Re: Joint Draft Environmental Impact Report/Environmental Impact Statement (EIR/EIS) for
East County Substation Project (State Clearinghouse No. 2009121079; DOI-BLM-CA-D070-
2010-0027-EIS (ECO SUB))

San Diego Gas & Electric Company (SDG&E) submits the attached comments to the California Public Utilities Commission (CPUC) and United States Department of Interior, Bureau of Land Management (BLM) on the Joint Draft Environmental Impact Report/Draft Environmental Impact Statement (EIR/EIS) for the proposed East County Substation Project (ECO Substation Project or Project).

Figure A-1: February 2011 ECO Substation Design

Figure A-3: Preliminary Underground Alignment Drawing 3 of 10

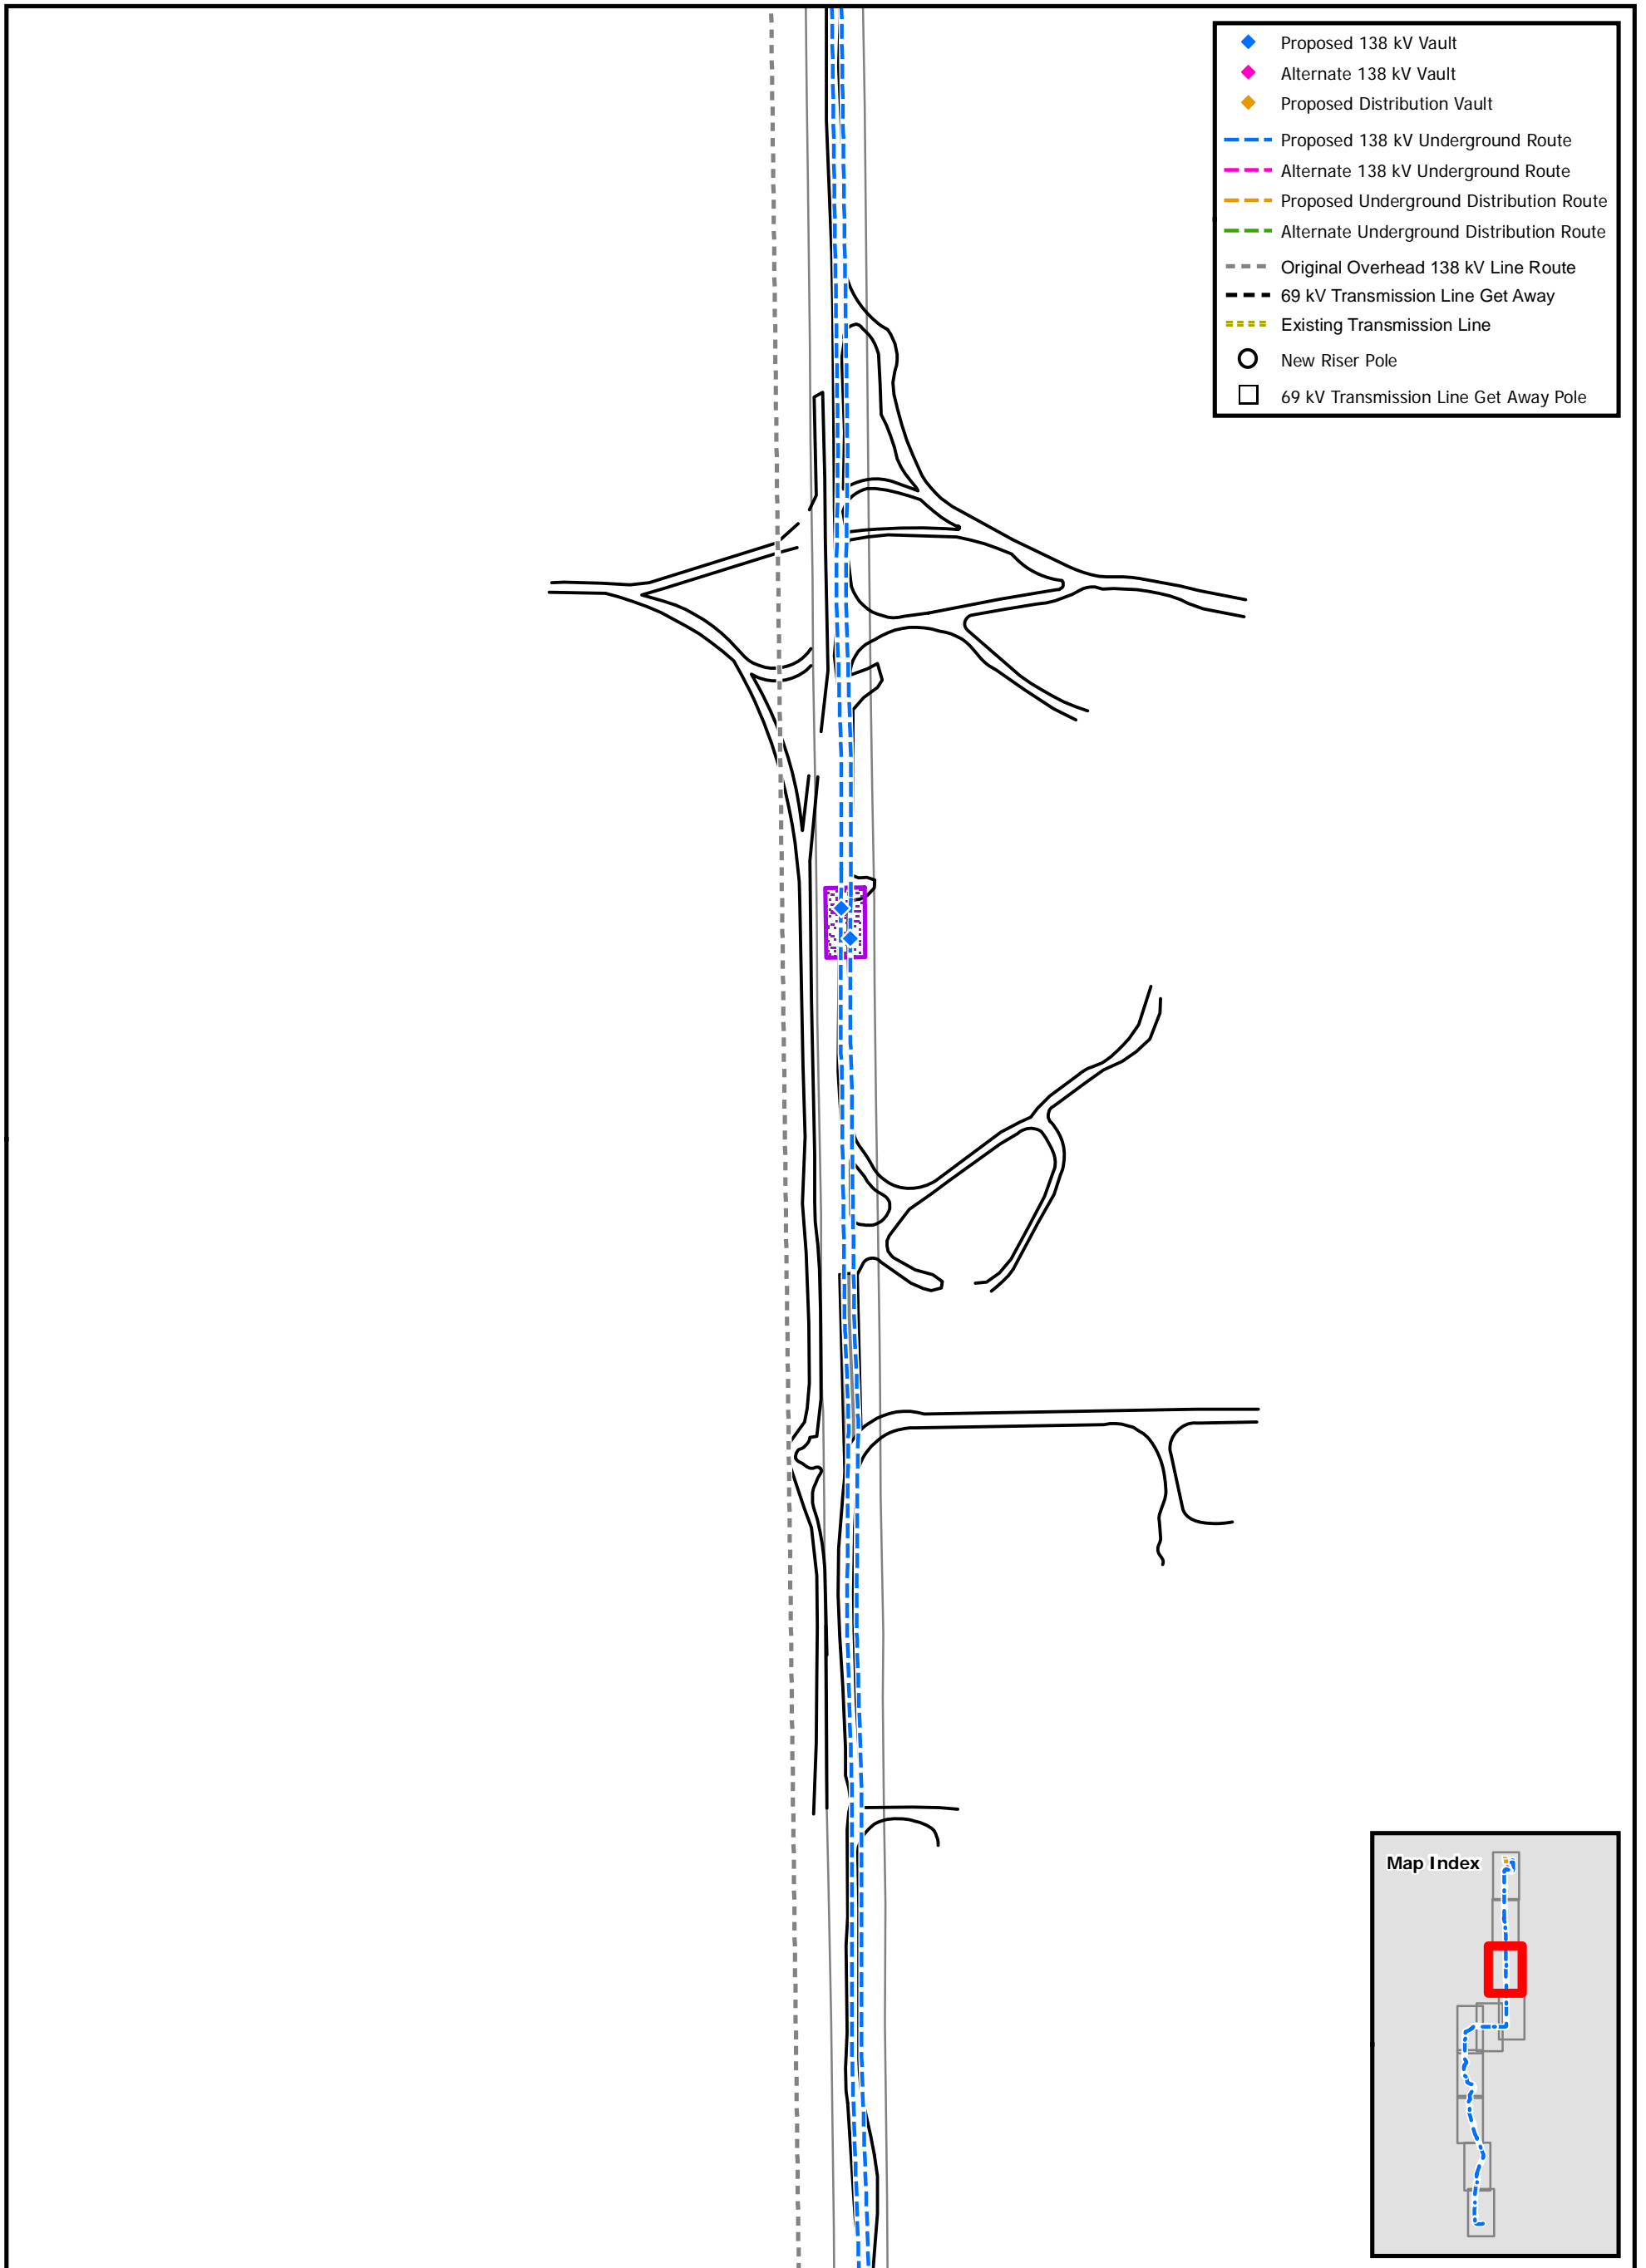
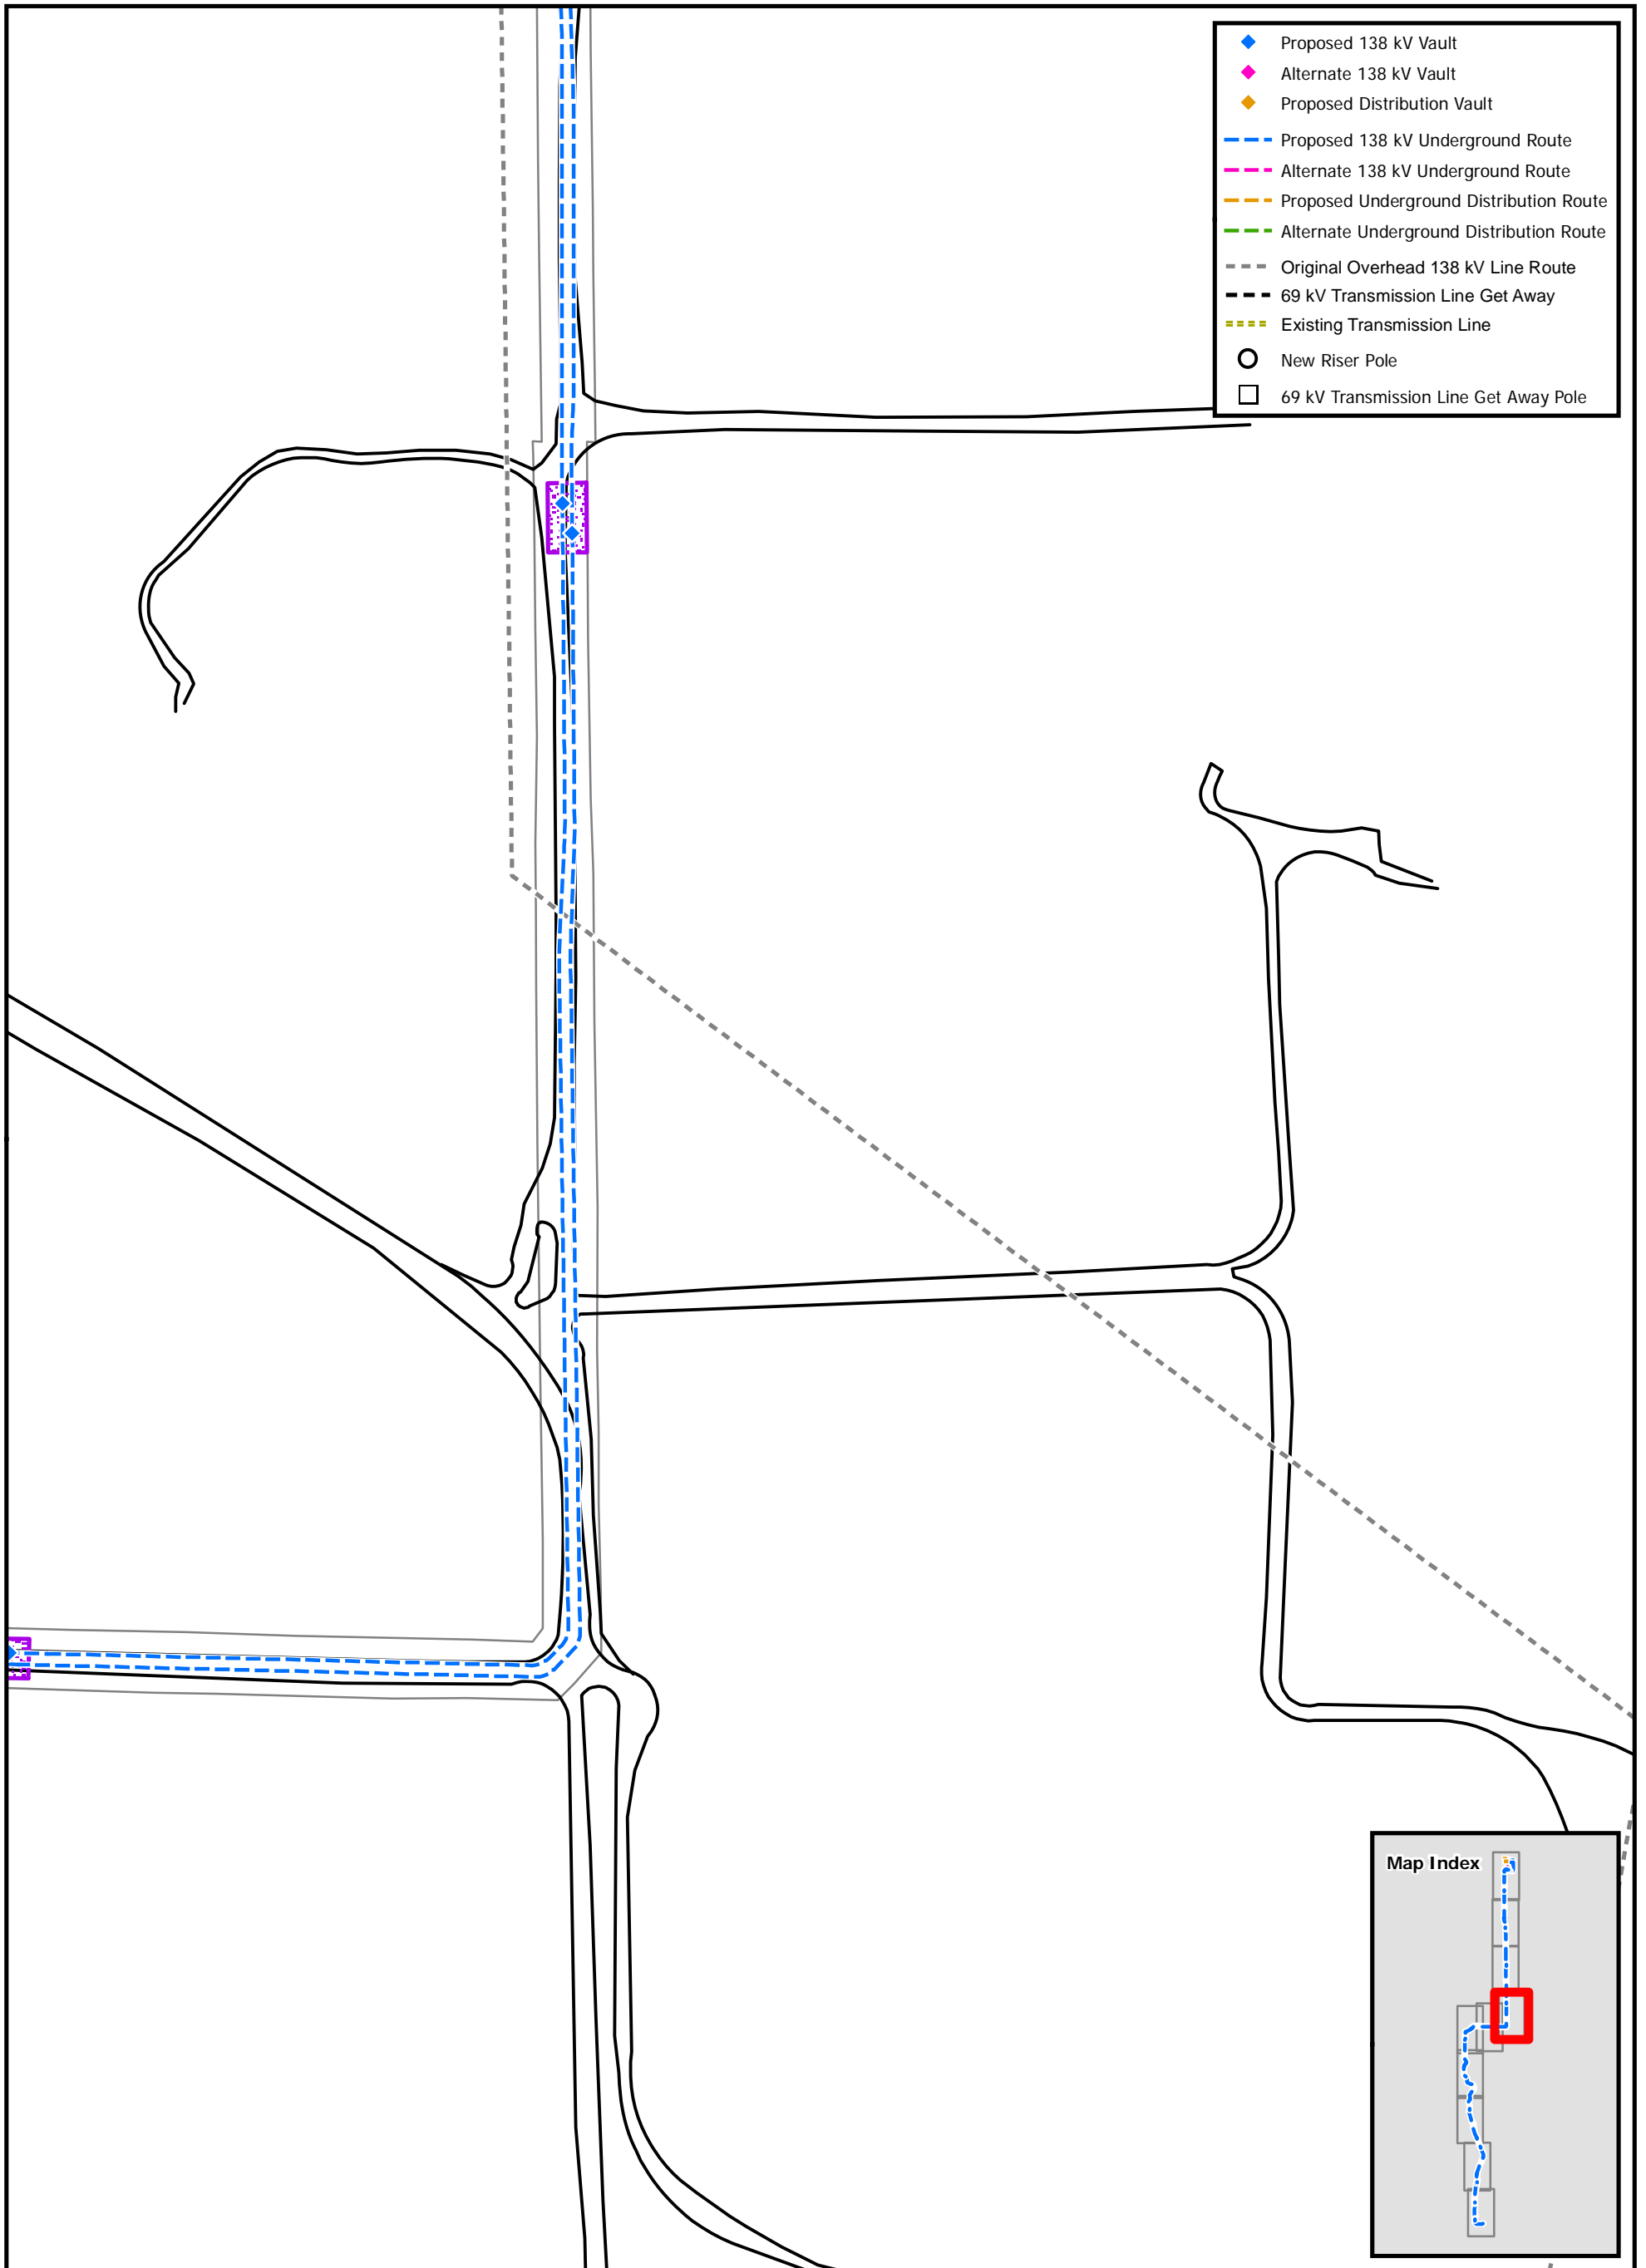
The impacts of the underground alignment were then determined based on a worst-case scenario (since there are two alternative routes into the substation as depicted in Figure A-3: Preliminary Underground Alignment Drawing that are substantially similar). As demonstrated in Table A-7: Preliminary Partial Underground Impacts, these impacts would not be substantial and would not therefore be significant.
